Board of Architectural Review

DATE: August 28, 2024
TO: Board of Architectural Review Chair and Members
THROUGH: Jason Sutphin, Community Development Division Chief JDS
FROM: Anna Kohlbrenner, BAR Liaison *AK*
SUBJECT: **Public Hearing: 10120 Fairfax Blvd – Taco Bell**

1. Case Number:	BAR-24-00087
2. Address:	10120 Fairfax Blvd
3. Request:	Restaurant with drive-through
4. Applicant:	ABTB Mid-Atlantic LLC
5. Applicant's Representative:	Kathryn R. Taylor
6. Status of Representative:	Attorney
7. Zoning:	CR Commercial Retail, Architectural Control Overlay District

SIGHT-LINE FOR ROOFTOP EQUIPMENT SCREENING

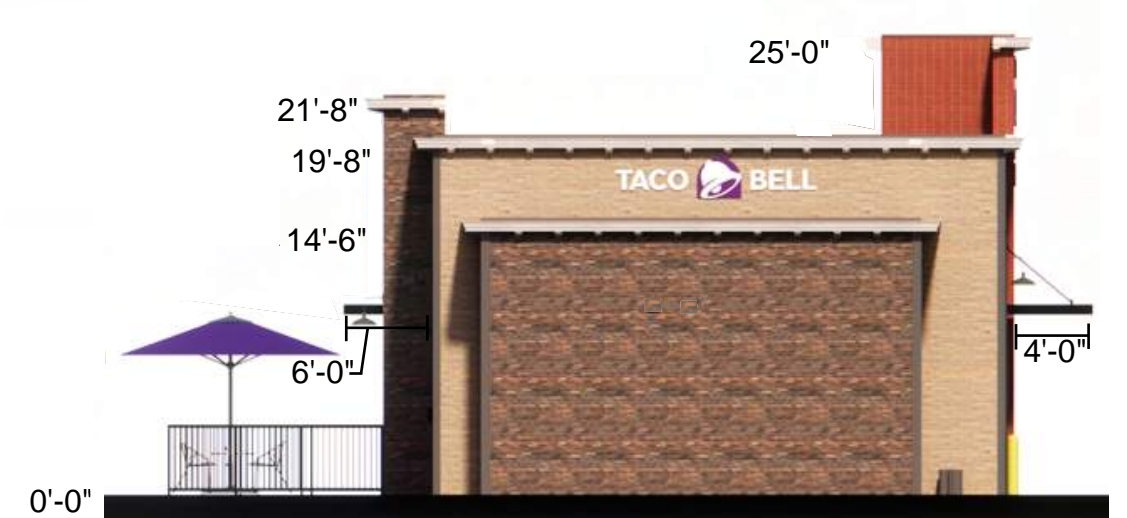
Roof-top mechanical would be fully screened by the roofline and would not be visible from the ROW in any direction.

THREE PROPOSED MATERIAL SAMPLES V. EXISTING BUILDING FACADE (GLEN GERY BURNT ALMOND USED ON THE EXISTING CENTER IS NOT BEING SUBSTITUTED)

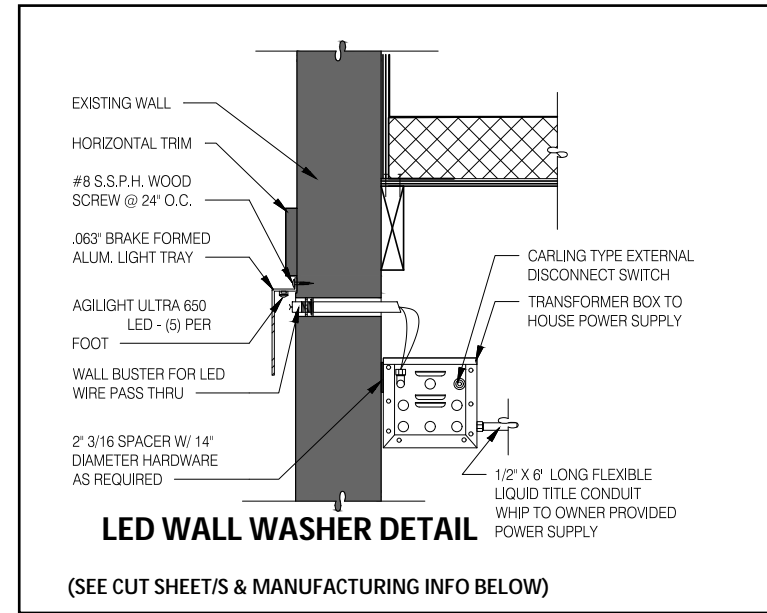
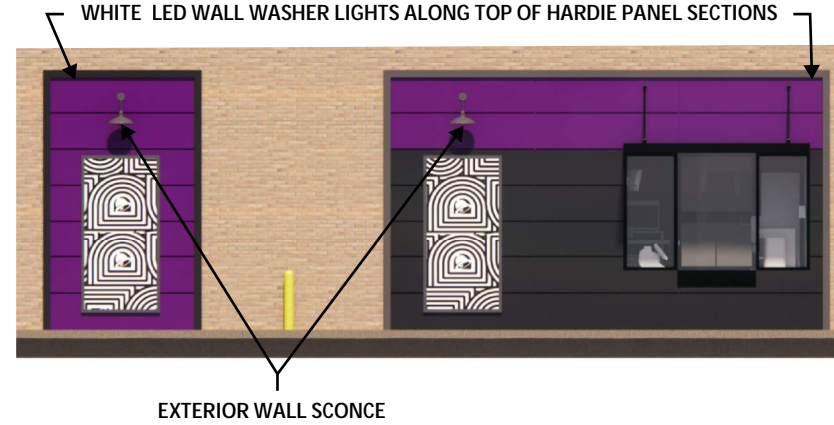
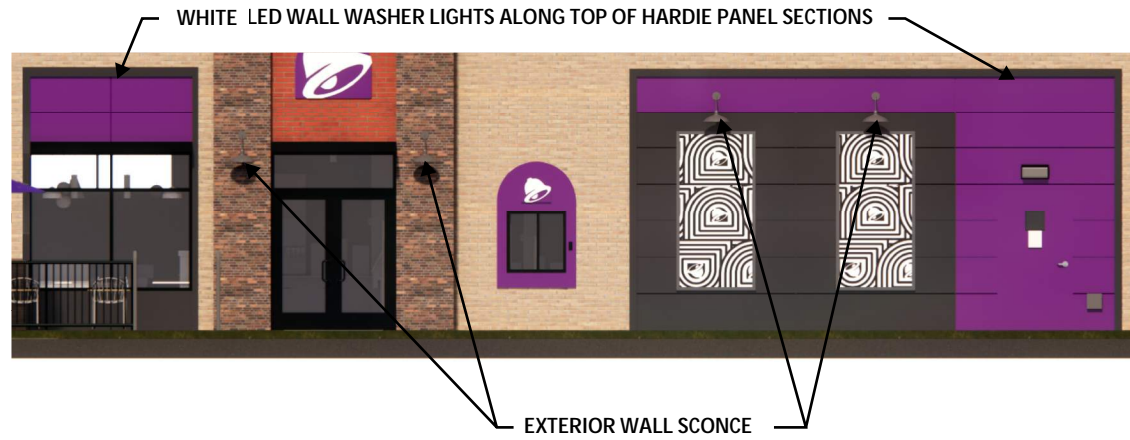
The applicant is proposing high quality materials including three different colors of brick that directly matches the shopping complex. The applicant is not proposing any EIFs.
